UNITED STATES PATENT AND TRADEMARK OFFICE

APPLICATION NO.	FILING DATE	FIRST NAMED INVENTOR	ATTORNEY DOCKET NO.	CONFIRMATION NO.
09/783,375	02/14/2001	Douglas Michael Johnescu	BERG-2572/C2685	2317

Office Action Summary

DETAILED ACTION

Fig. 2

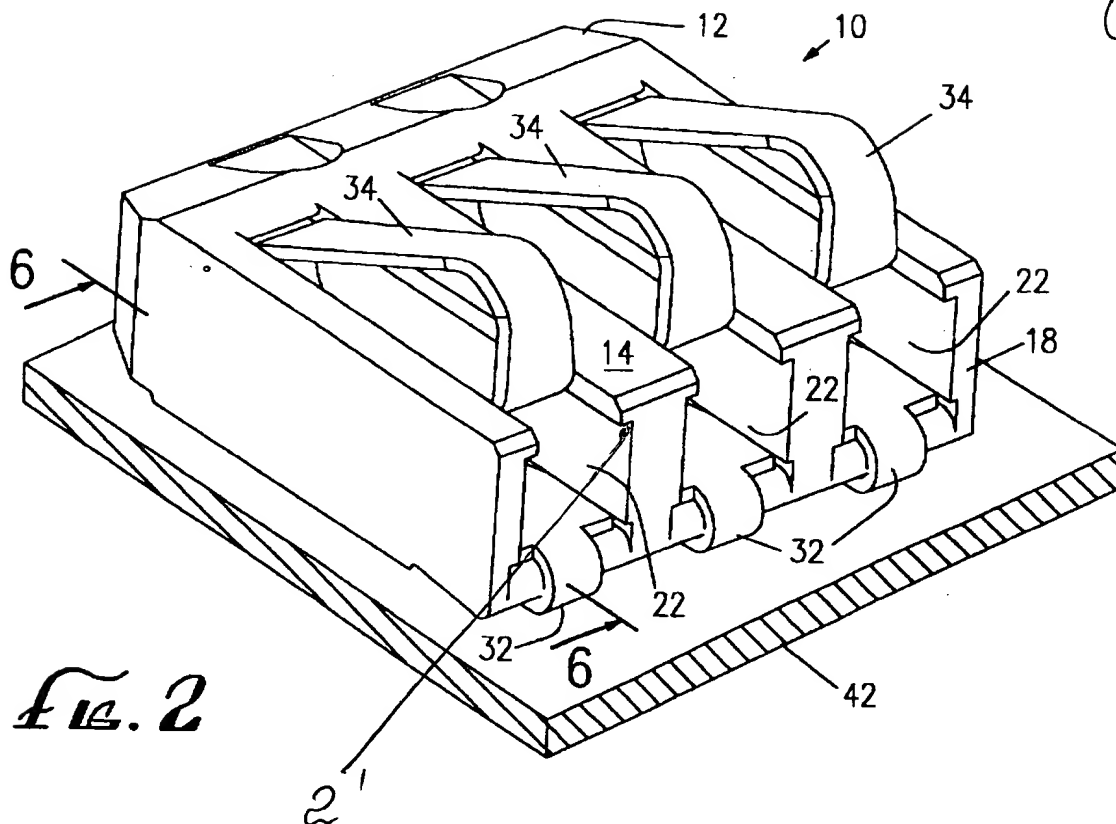
Claims 16-20 and 22 are rejected under 35 U.S.C. 103(a) as being unpatentable over Kwiat et al. (5746626) in view of Walkup et al. (5989049). Kwiat discloses a housing 12, a plurality of contacts 28 extending through the housing and exhibiting a preload (see Fig.2) and a retention structure 2' (see attachment 1, Fig. 2). The contacts

are oriented in the same direction. Kwait does not discuss the contacts preloaded but includes the structure that provides it, such as **tabs** (1') on the distal end of portion 34 and **shoulders** (2') on the top of the compartment 22 and top wall 14 (see Figs. 2 and 3 in the attachment 1).

In regards to claim 20, each contact 28 includes a medial section (not labeled, an area abuts a wall 16), a mounting portion 32, and a compressive mating portion 34 having a distal end, wherein the retention structure 2' (see attachment 1) engages the distal ends (not labeled, lower part of mating portion 34) to preload the contacts (see Figs. 1 and 2).
